CORRIGENDUM 1

Figure 2 – Flow charts test sequence to be applied when performing the type test (Figure 2a) and routine test (Figure 2b)

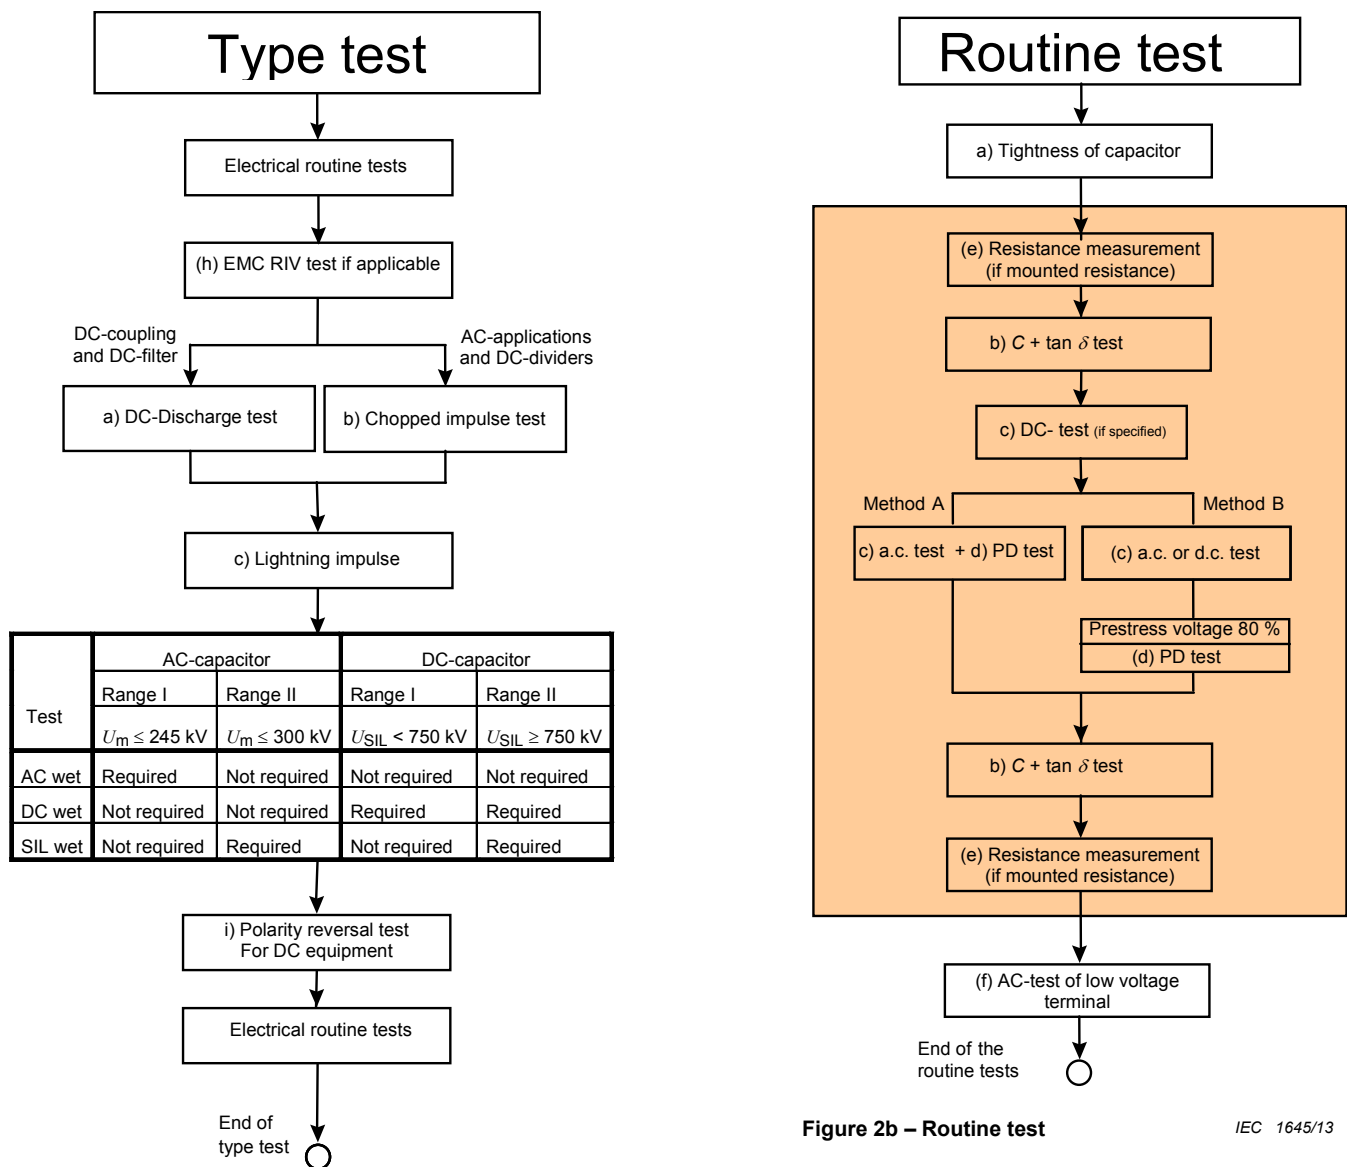
The order or possible combination of the tests is not standardized except for the highlighted test in Figure 2.

Replace the existing Figure 2 with the following new figure:
